**ALLEGHENY COUNTY SANITARY AUTHORITY**

**CONTRACT NO. 1729 G, E, H, P**

**EAST HEADWORKS**

**ADDENDUM NO. 11**

**CANOPY ROOF PLAN**  
SCALE: 1/4" = 1'-0" 530-A-15

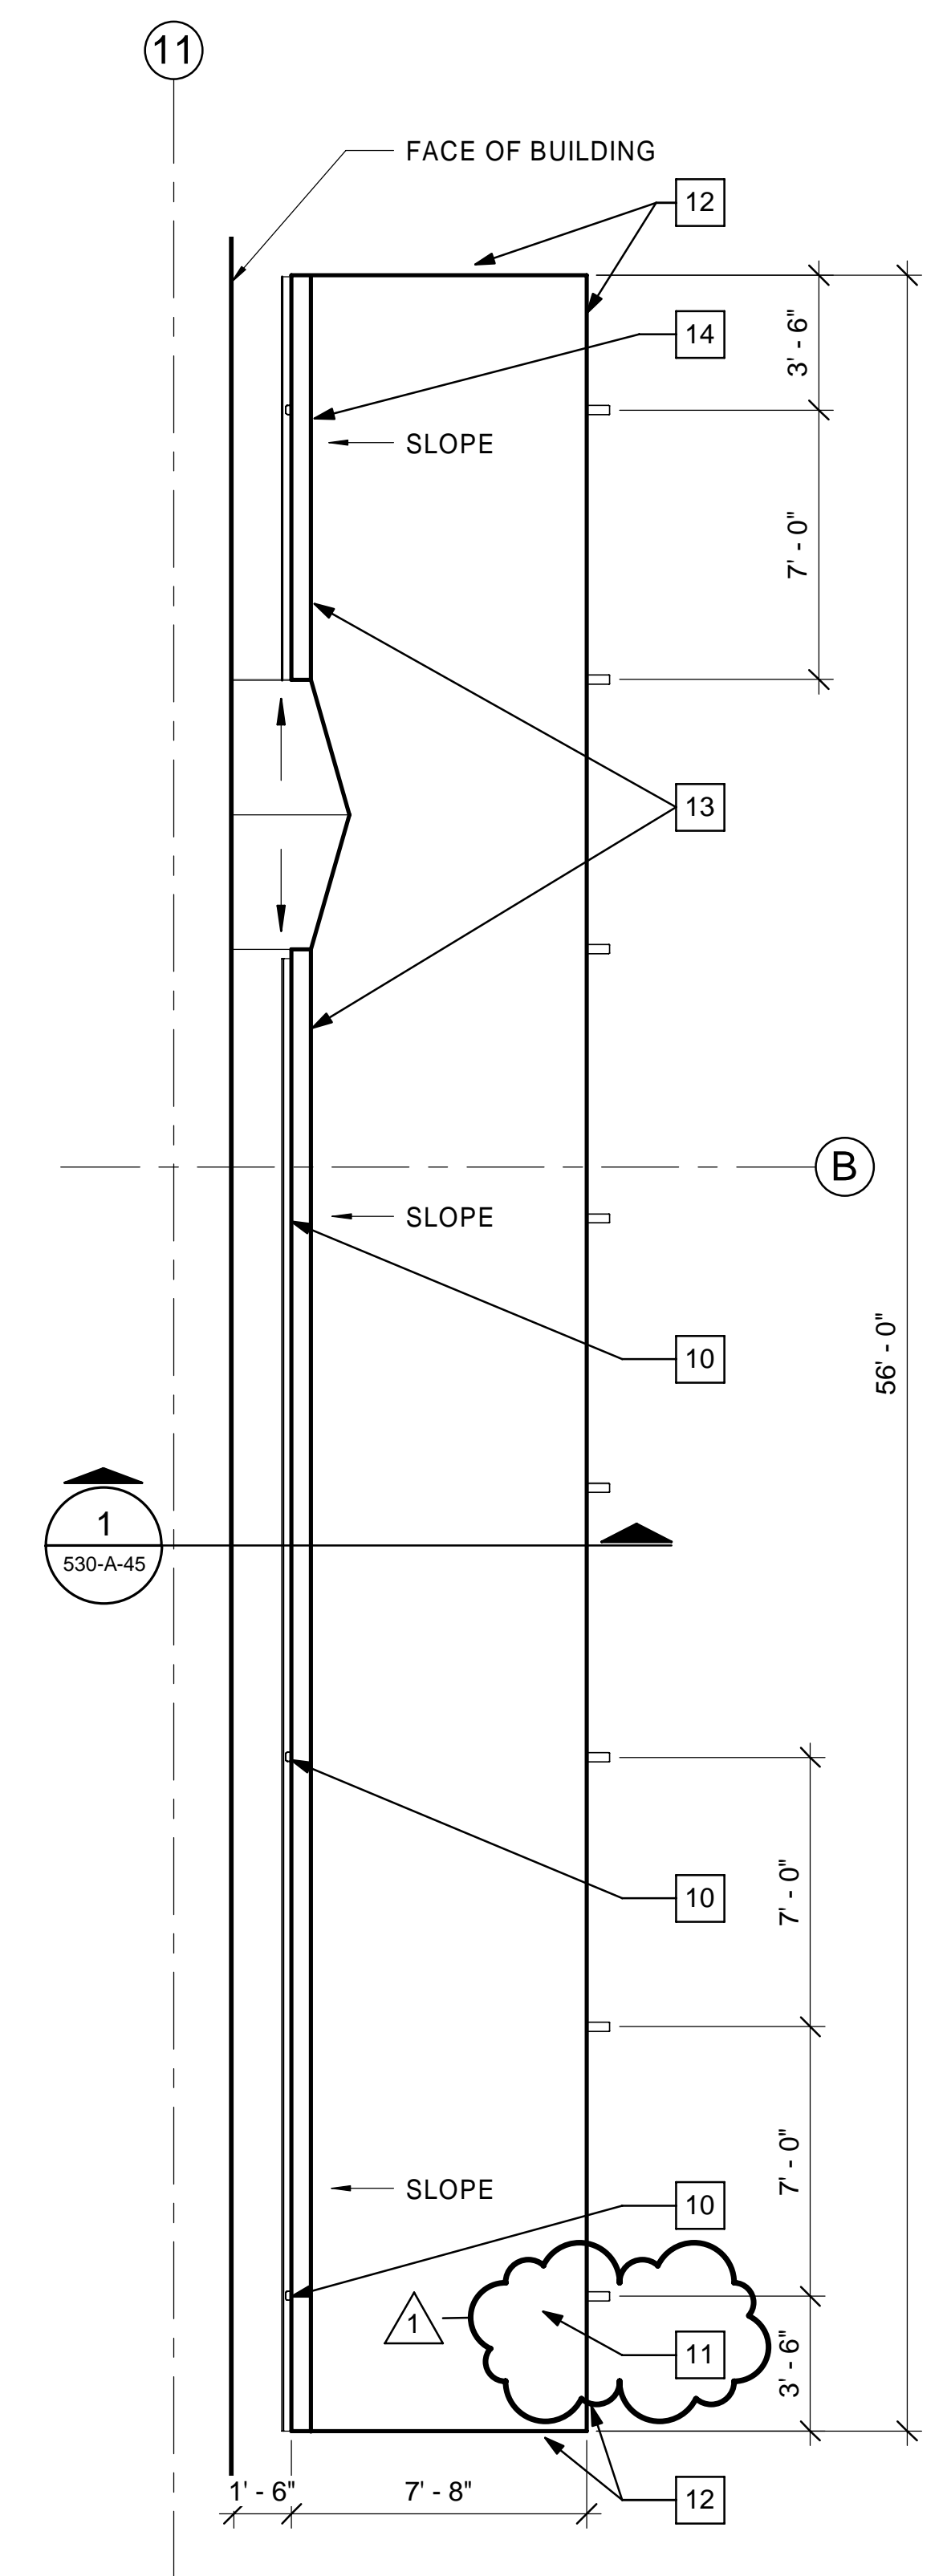
6. Drawing 530-A-15
  - a) **DELETE** this drawing and **REPLACE** with the attached drawing 530-A-15.
7. Drawing 530-A-19
  - a) **DELETE** this drawing and **REPLACE** with the attached drawing 530-A-19.
